## The following items are conditions for permit issuance and strict compliance is mandatory.

Figure 1. Recommended construction details for APA portal frame bracing without hold-downs

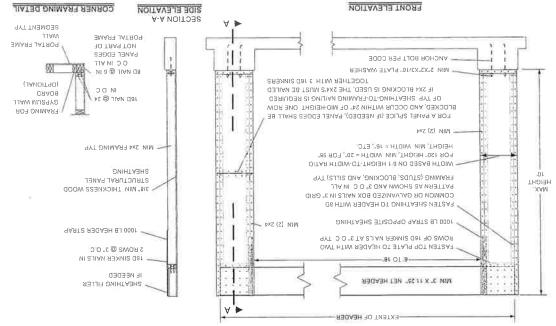
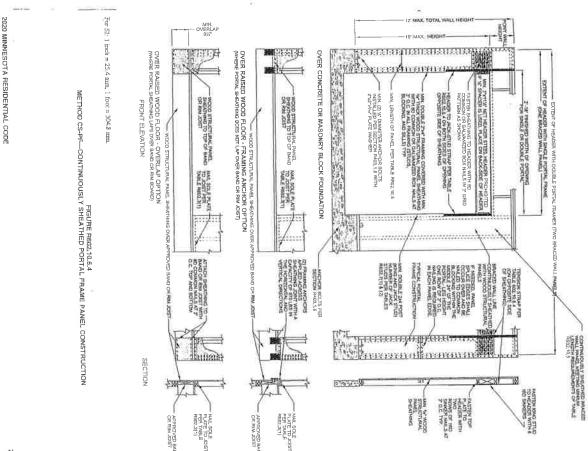
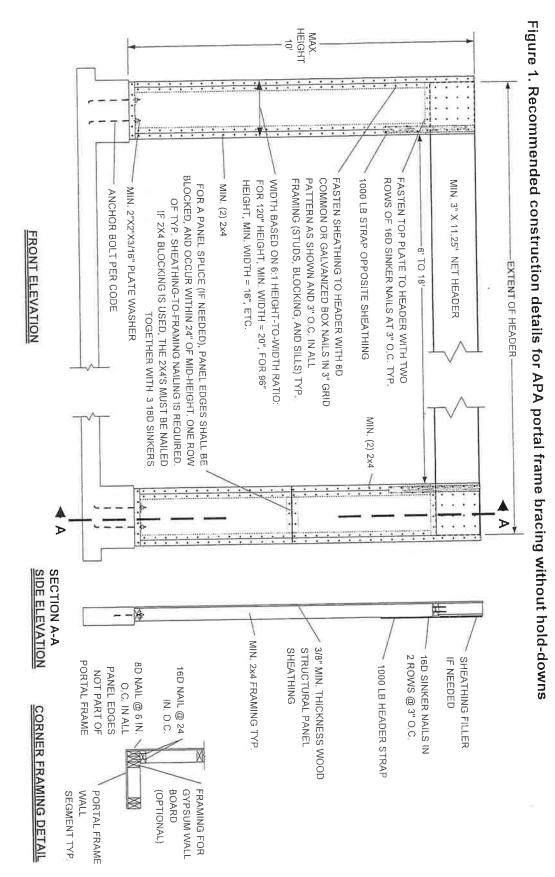
- 11. Smoke alarms required in all areas leading to sleeping rooms and on all levels, and shall not be installed less than 3 feet from a door to a bathroom containing a bathtub or shower. MSBC1309/R314.3
- 12. Provide ice dam protection on all roof edges. Protection shall extend from the eave's edge to a point at least 24" inside the exterior wall line. MSBC1309/R905.2.7.1
- 13. No final building inspection will be conducted prior to the installation of a water meter and a remote water meter read out.
- 14. Wall section on the front of the garage less than 2'-8" wide shall be braced wall panels.(see attached) MSBC1309/R602.10
